Subject: Cabot Reading Site, Reading, Pennsylvania (License No. SMC-1562)
Radiological Assessment and Decommissioning Plan
Rip-Rap Cover Design Modifications

CABOT
Reading, Pennsylvania Slag Pile Site
Revision 3 Replacement Pages Instructions

**Revision 3
June 2005**

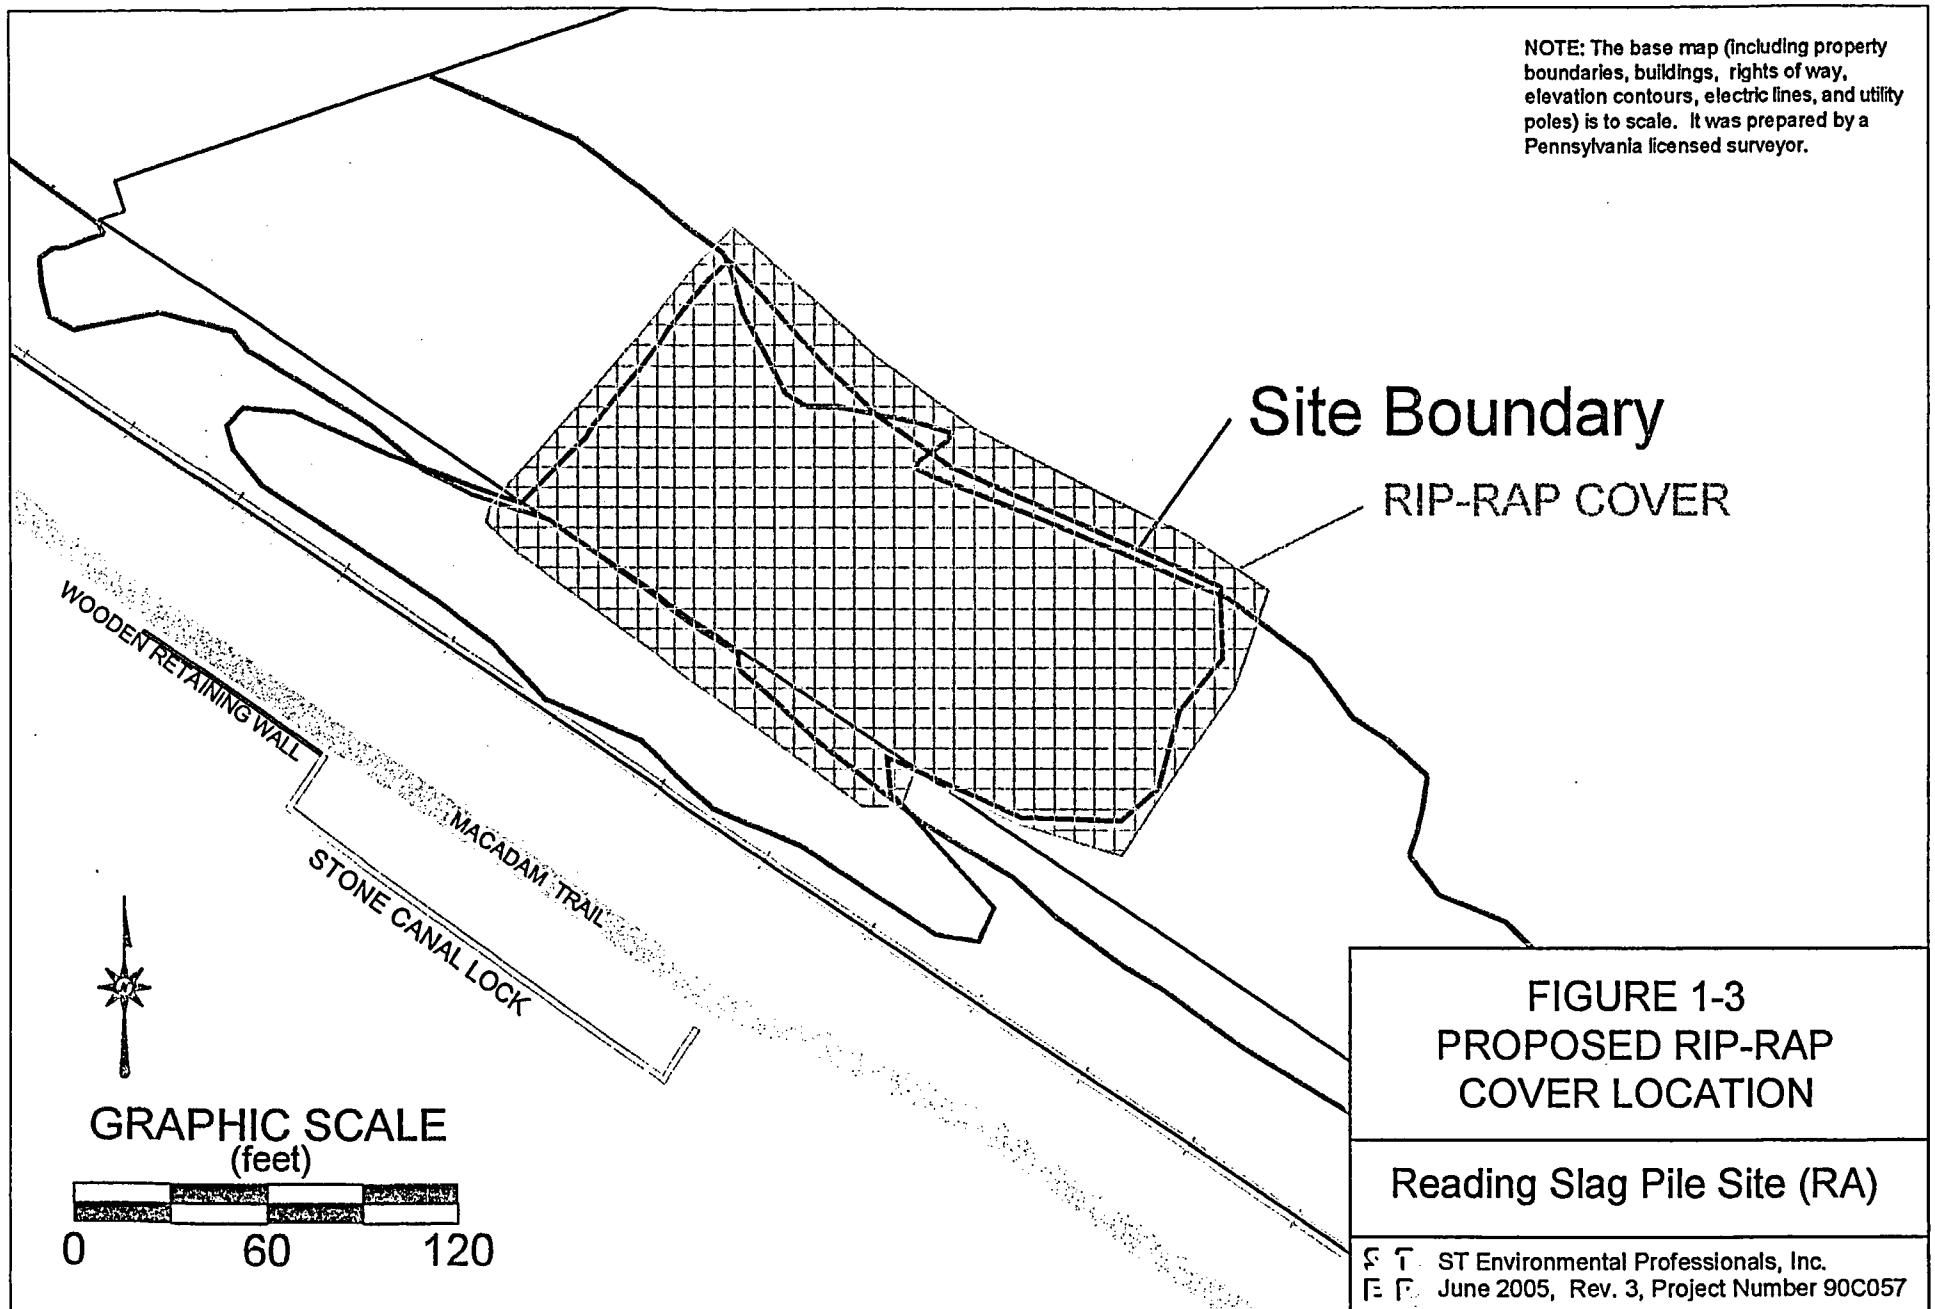
The Decommissioning Plan incorporates emplacement of 1.0-foot thick layer of rip-rap, on the slag pile slope face and along the top edge. A 2.3-foot thick rip-rap apron will extend 11 feet from the bottom of the slope into the River Road ROW to anchor the slope. The rip-rap is intended primarily for added assurance that erosion will not occur over the period of interest. Given this limited purpose and the self-armoring properties of such measures, this feature constitutes a passive engineered barrier, as described in NRC guidance (USNRC, 2003b, Section 3.5). The rip-rap cover is designed to remain effective for erosion control for 1,000 years without maintenance. Consequently, no institutional controls will be required after license termination.

The rip-rap cover on the slope and top edge will consist of a 1.0 foot thick layer of durable rock sized $D_{50}=6''$ (USA number R-4 rip-rap). This exceeds the size criteria calculated using NUREG-1623 methods of $D_{50} = 1.3$ for the slope. An apron of rip-rap will be placed extending 11 feet out from the toe of the slope to anchor the rip-rap cover. This will eliminate the need to excavate slag at the toe of the slope. The apron will consist of USA number R-5 rip-rap ($D_{50} = 9''$). This exceeds the design calculation of $D_{50} = 7.2''$. The apron will be 2.3-feet thick to facilitate proper placement of the large size rip-rap. Additional design details are provided in the Decommissioning Plan (STEP, 2005). Figure 1-3 depicts the location and extent of the proposed rip-rap cover. Figure 3-2 depicts the typical cross section.
